ALAMEDA COUNTY
HEALTH CARE SERVICES

March 11, 2008

Subject: Fuel Leak Case No. RO0000184 and Geotracker Global ID T0600102125, Precision Trucking School, 300 Hegenberger Road, Oakland, CA 94621

Alameda County Environmental Health (ACEH) staff has reviewed the case file for the above-referenced site including the most recent document entitled, "*Soil Excavation Work Plan, 300 Hegenberger Road, Oakland, California,*" dated July 23, 2007. The Work Plan, which was prepared by ACC Environmental Consultants, proposes excavation of petroleum hydrocarbon-impacted soil to a depth of approximately 4 feet bgs in the area of two former gasoline dispensers. Based upon our review of the case file, there are several issues described in the technical comments below, which should be addressed prior to implementing a remedial excavation. Therefore, we request that you prepare a Work Plan that addresses the technical comments below.

Attachment A

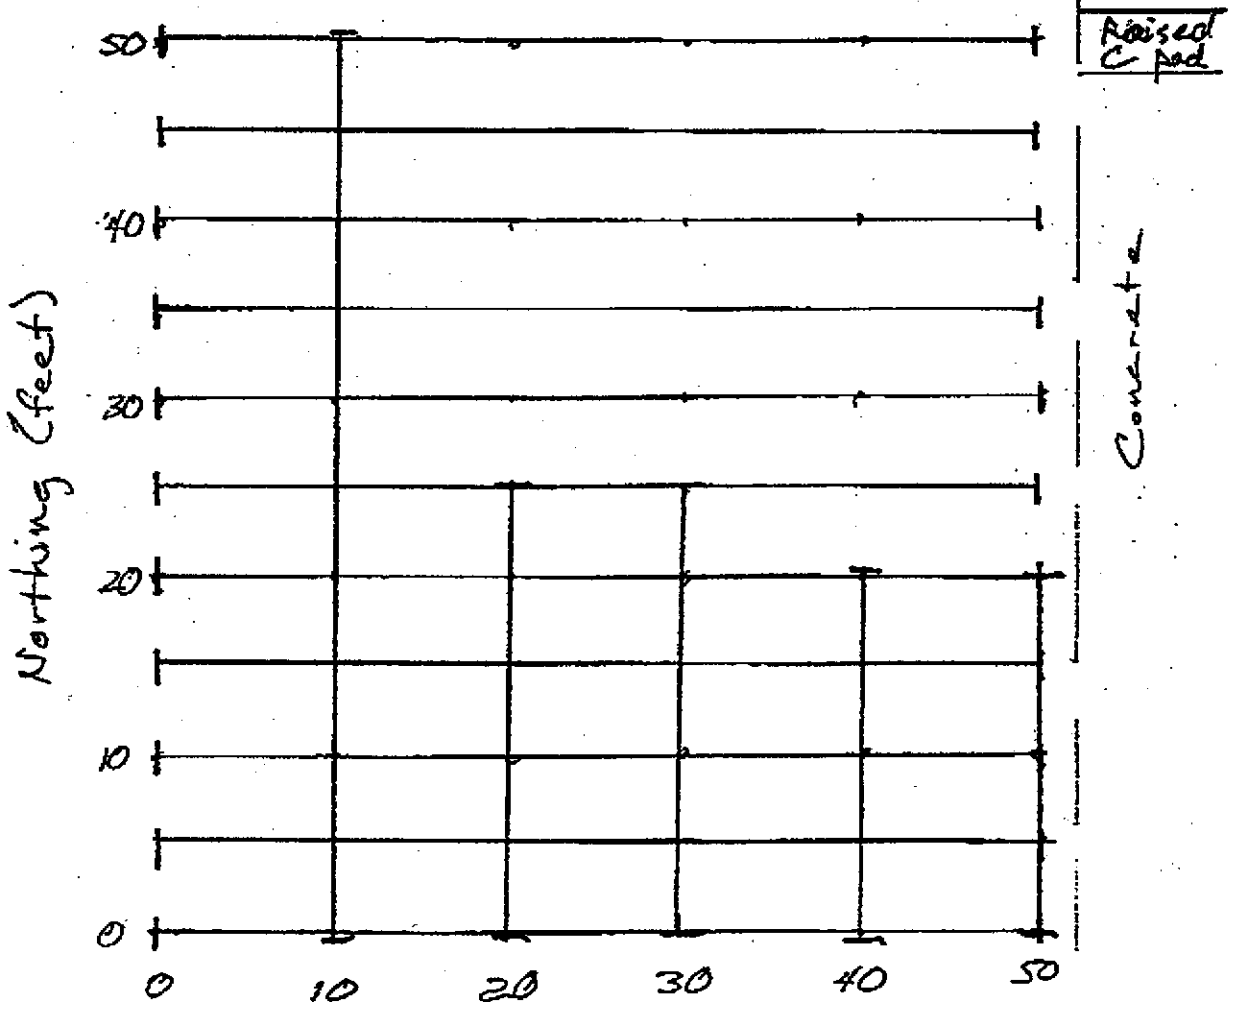
6. **Base Map.** Please confirm the former location of the waste oil tank for future base maps of the site. Figure 2 of the Work Plan prepared by ACC Environmental Consultants attributes the map source to Northwest Envirocon, Plate 2, December 1997. Plate 2 in the December 1997 Northwest Envirocon report shows the former waste oil tank in a location further south than Figure 2 of the ACC Environmental Consultants. Please review the available information to confirm an accurate location for the former waste oil tank and other site features.

Attachment B

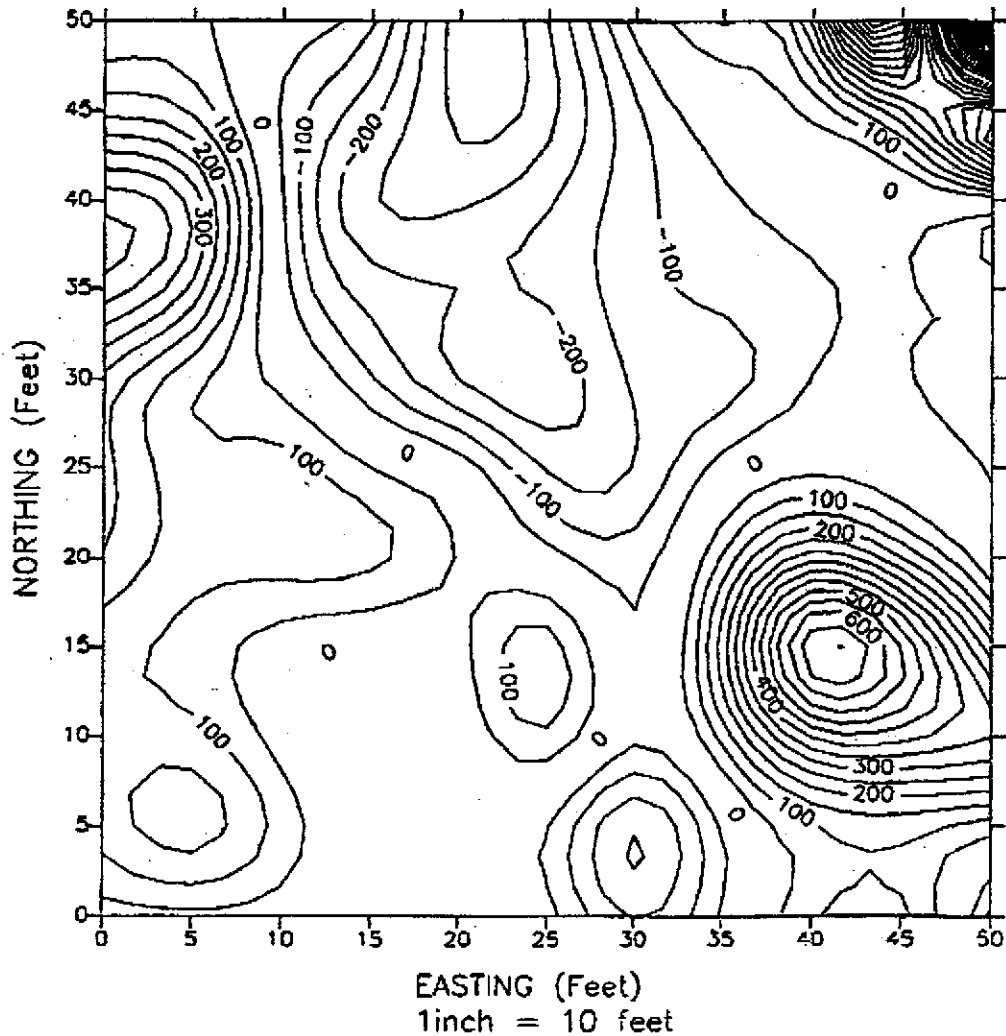
3. **UST Location.** Previous reports for the site have indicated that no documentation exists regarding the locations or removal of the fuel USTs for the service station. Please confirm that City of Oakland Fire Department UST files for the site have been reviewed. If City of Oakland Fire Department records have not been reviewed, please review files for the site to help verify the location and removal of the USTs. A geophysical survey was conducted at the site on July 24, 1997 and trenching was conducted on October 8, 1997 in an attempt to locate the USTs. Attachment A, which is a map prepared by Northwest Envirocon, Inc. shows both the geophysical survey and trenching conducted in the western corner of the site. However, a review of the maps prepared by Norcal Geophysical Consultants suggests that the geophysical survey was conducted in an area further to the south. Attachment B shows a hand-drawn scaled map of the survey grid. The two points of reference on the map are the former concrete dispenser islands in the northeastern corner of the grid. Attachment C shows a large magnetic anomaly approximately 35 feet south and 10 feet west of the southernmost dispenser island. Based on the location shown on Attachment C, this large magnetic anomaly appears to be approximately 25 feet northwest of monitoring well MW-6. In the Work Plan requested below, please indicate whether the area of the large magnetic anomaly was investigated for the presence of a UST. If this area was not investigated, please propose additional investigation to determine whether a UST may remain in place.
